AGENDA
CITY OF KENTWOOD PLANNING COMMISSION
TUESDAY, JULY 27, 2021
KENTWOOD COMMISSION CHAMBERS
4900 BRETON AVENUE
7:00 P.M.

PROPOSED MINUTES OF THE REGULAR MEETING
OF THE KENTWOOD PLANNING COMMISSION
TUESDAY JULY 13, 2021, 7:00 P.M.
COMMISSION CHAMBERS

STAFF REPORT: July 12, 2021
PREPARED FOR: Kentwood Planning Commission
PREPARED BY: Lisa Golder
CASE NO.: 20-21 DMS IPUD

To: Kentwood Planning Department
From: Brad Boomstra, P.E.
City Engineer
Date: July 13, 2021
Re: **DMR Transportation**
4401, 4375, 4251 36th Street SE
41-18-13-400-004, 41-18-13-390-027, & 41-18-13-390-026
Review of Site Plan Received 7-12-2021

PRELIMINARY I-PUD - COVER SHEET

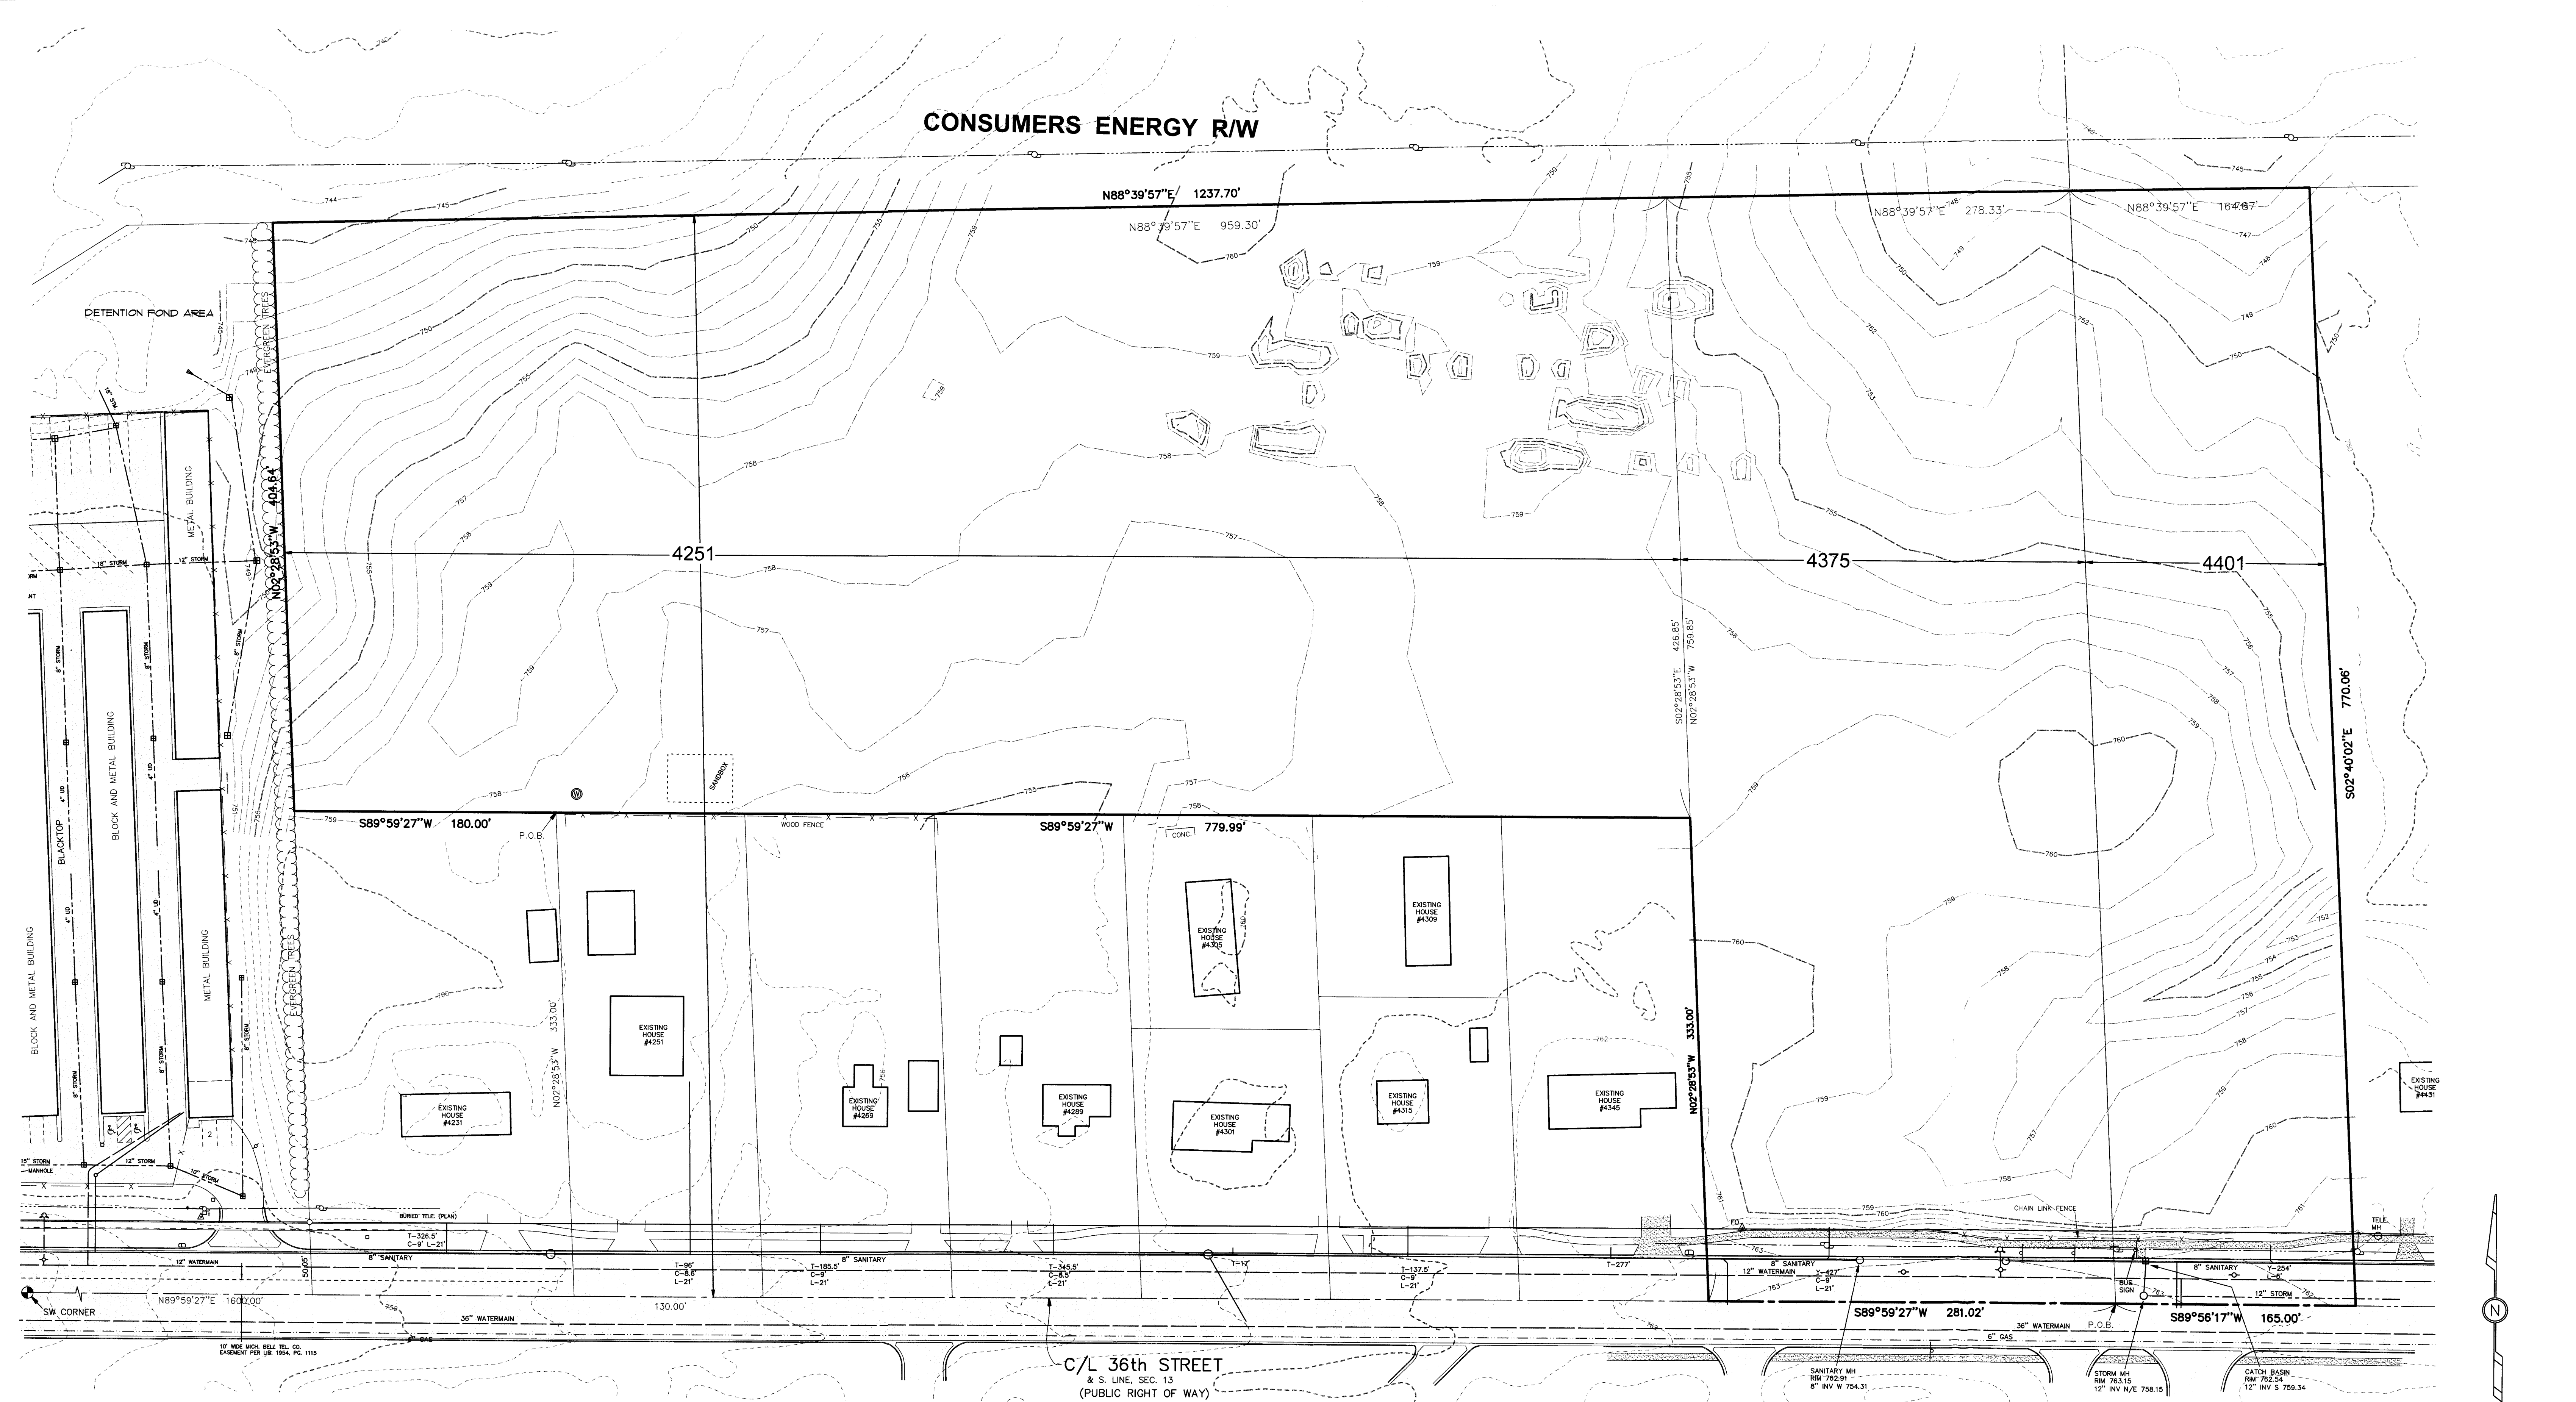
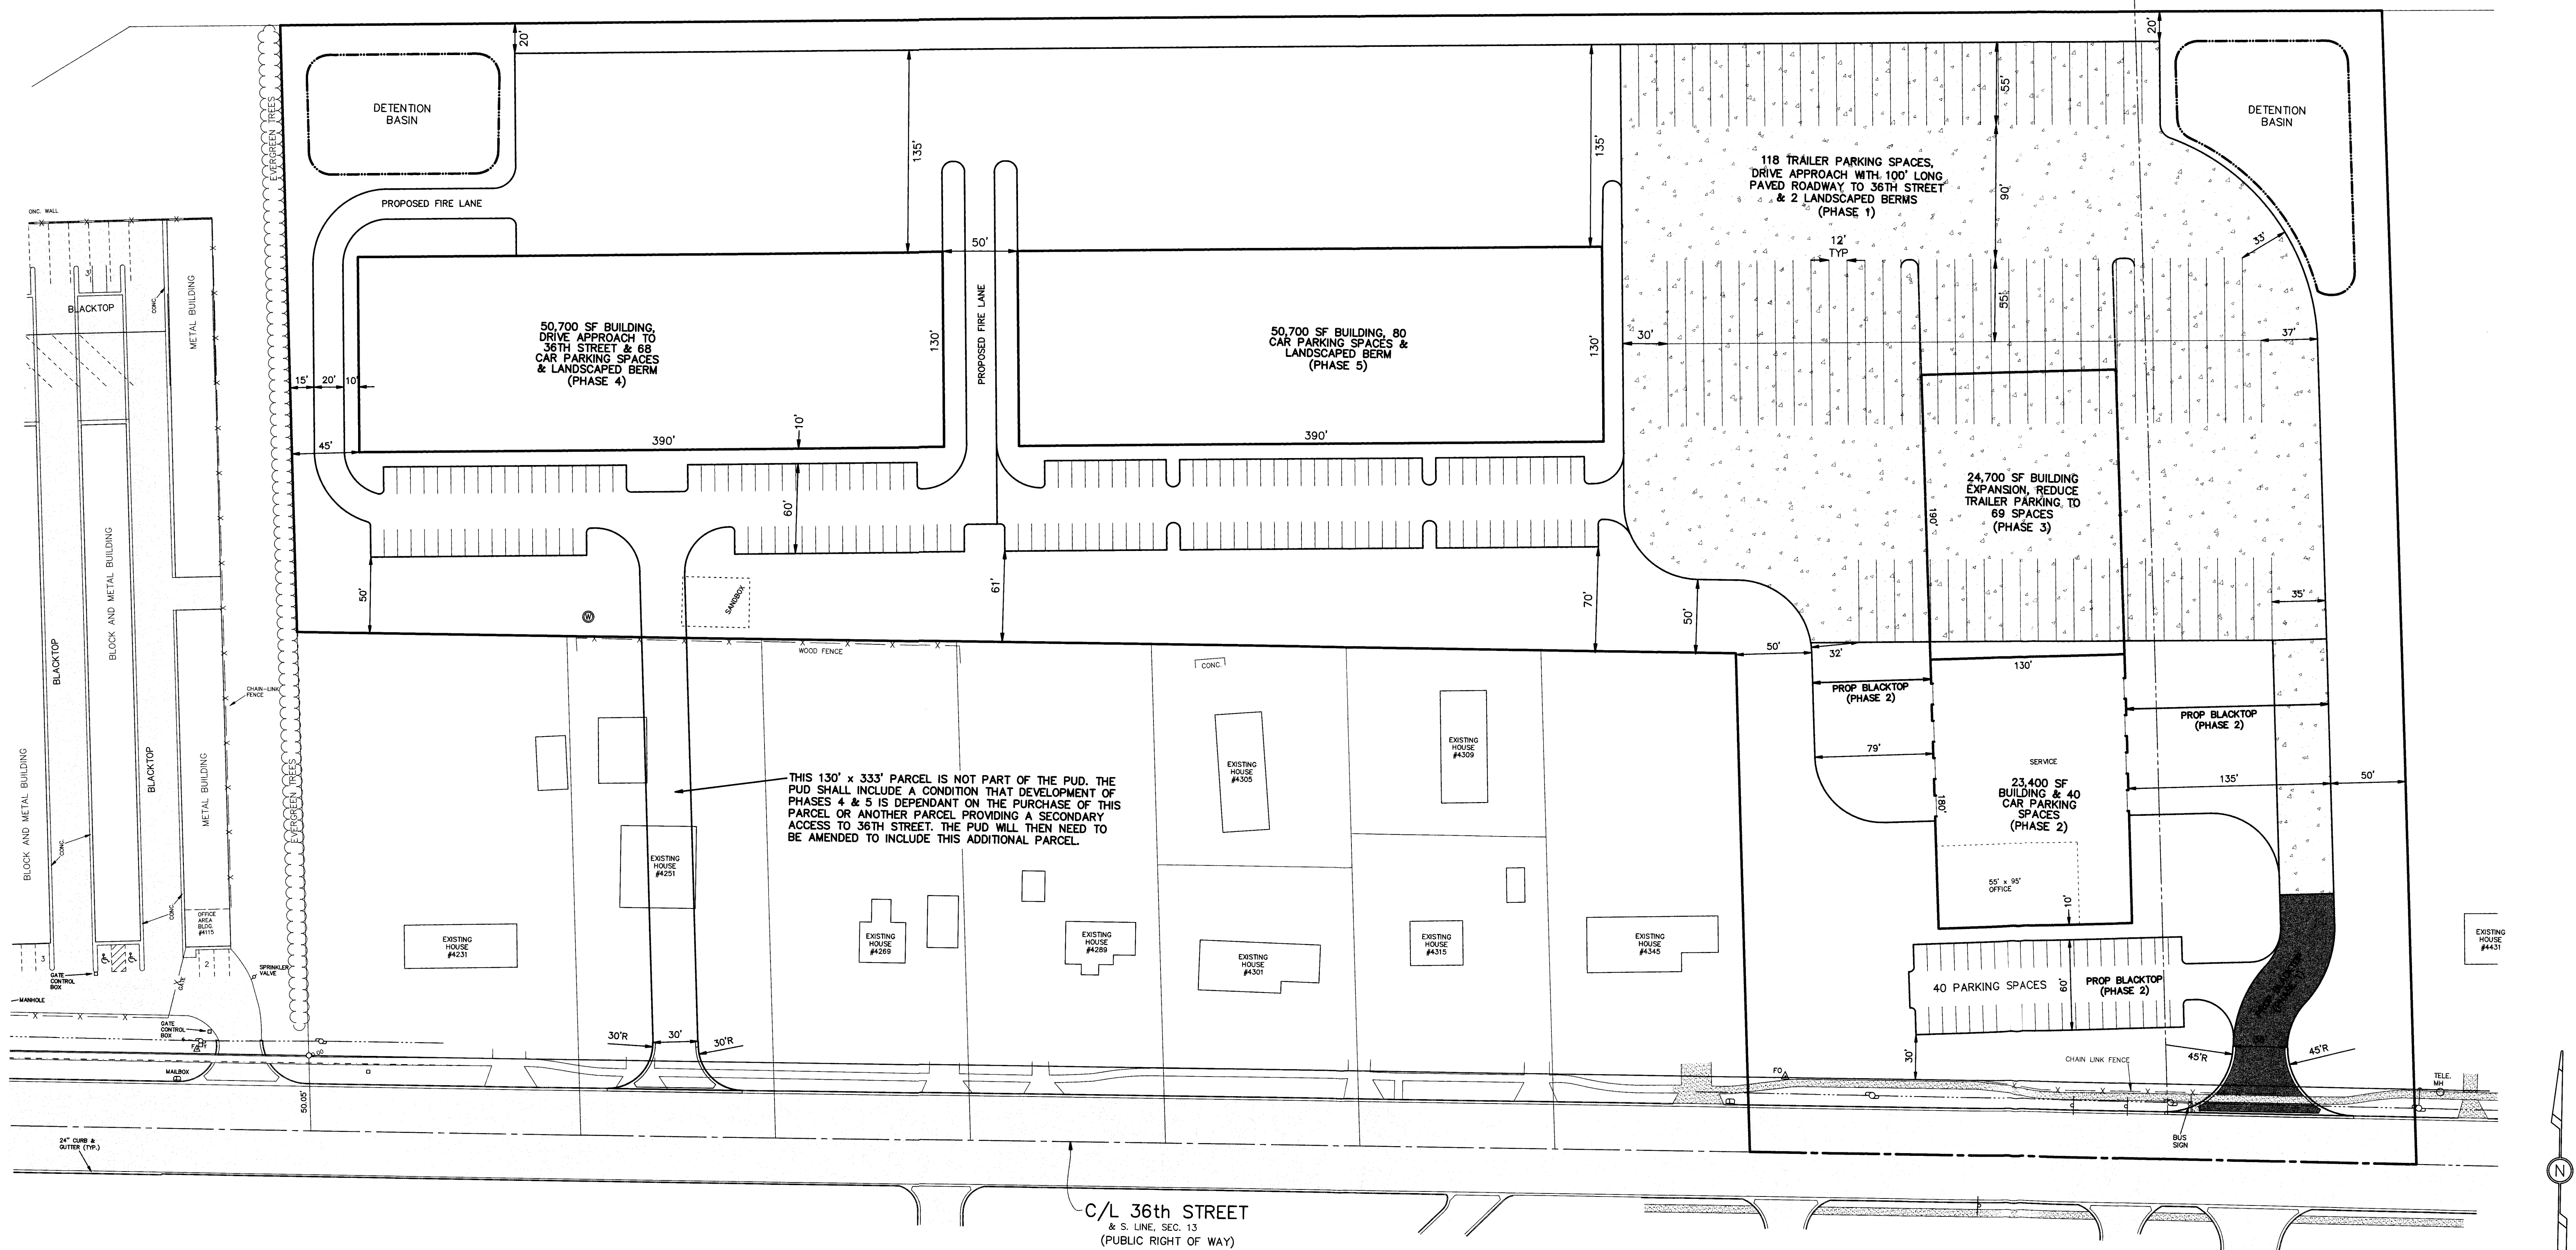
While there is not enough information to provide a complete review, Kentwood Engineering has the following comments that will need to be addressed before site plan construction review.

1. Include parcel numbers on the plans.
2. The cover sheet, watermain and sanitary sewer plan sheets must be prepared in accordance with the City of Grand Rapids drafting standards. Any improvement sheet(s) listed in the sheet index on the cover sheet must include the words, "FOR REFERENCE ONLY".
3. The multiple parcels at this site must be combined into a single parcel. This is required whenever new development spans across adjacent parcels. Please contact the Kentwood Assessor, regarding this procedure.

1. The pavement within the commercial drive approach between the sidewalk and the gutter pan must be concrete at least 6 inches thick.
2. No single curb cut shall be less than 10 feet in width, nor more than thirty (30) feet in width.
3. For any curb cut which terminates less than five (5) feet from a construction joint, the contractor shall remove and replace the existing curb to the next joint.
4. Include the City of Kentwood General Notes on the plan(s). These notes are required for the work being performed in the 36th Street right-of-way. Highway permit conditions, specifications and required general plan notes are posted on the City's website, and can be accessed at <http://www.ci.kentwood.mi.us> (hover over "CITY SERVICES" and "DEPARTMENTS" then click "ENGINEERING", then click the "RIGHT-OF-WAY" link near the top of the page).
